UNITED STATES
DEPARTMENT OF THE INTERIOR
BUREAU OF LAND MANAGEMENT

SUNDRY NOTICES AND REPORTS ON WELLS
Do not use this form for proposals to drill or to re-enter an abandoned well. Use form 3160-3 (APD) for such proposals.

8. Well Name and No.
PEACHES 19 FEDERAL 3H

OXY USA Inc. respectfully requests approval for the following changes to the drilling plan:

5M BOP Stack

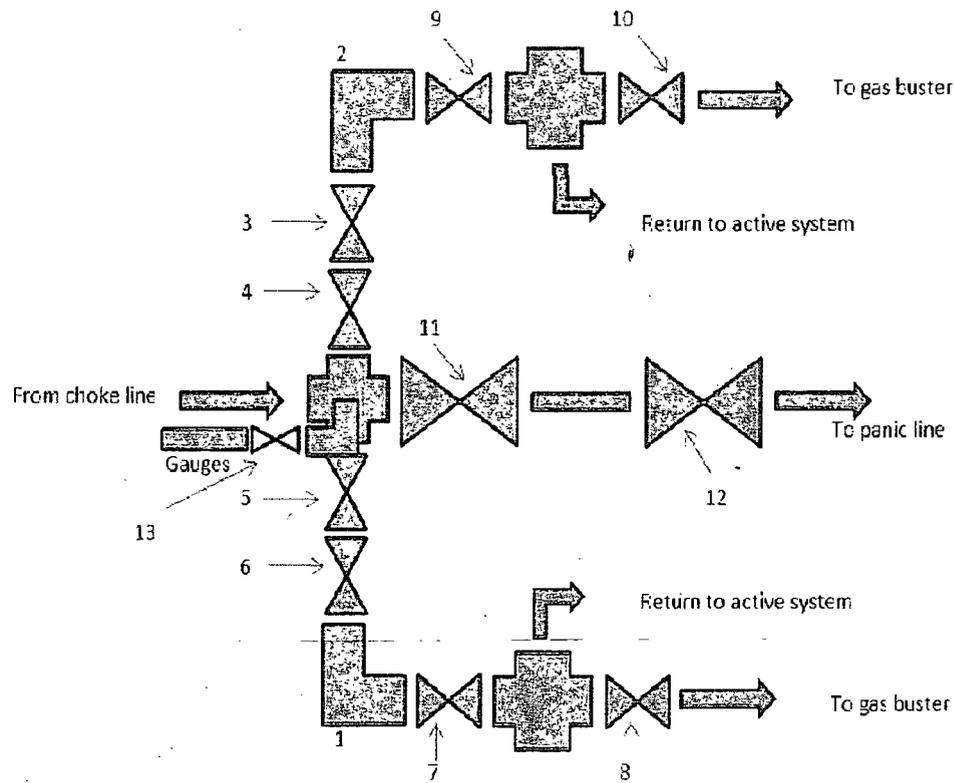
4. The Operator will connect the BOP choke outlet to the choke manifold using a hose that meets all BLM requirements and will be inspected and approved by BLM personnel prior to spud.

2. Variance approved to use flex line from BOP to choke manifold. Check condition of flexible line from BOP to choke manifold, replace if exterior is damaged or if line fails test. Line to be as straight as possible with no hard bends and is to be anchored according to Manufacturer's requirements. The flexible hose can be exchanged with a hose of equal size and equal or greater pressure rating. **Anchor requirements, specification sheet and hydrostatic pressure test certification matching the hose in service, to be onsite for review. These documents shall be posted in the company man's trailer and on the rig floor.** If the BLM inspector questions the straightness of the hose, a BLM engineer will be contacted and will review in the field or via picture supplied by inspector to determine if changes are required (operator shall expect delays if this occurs).
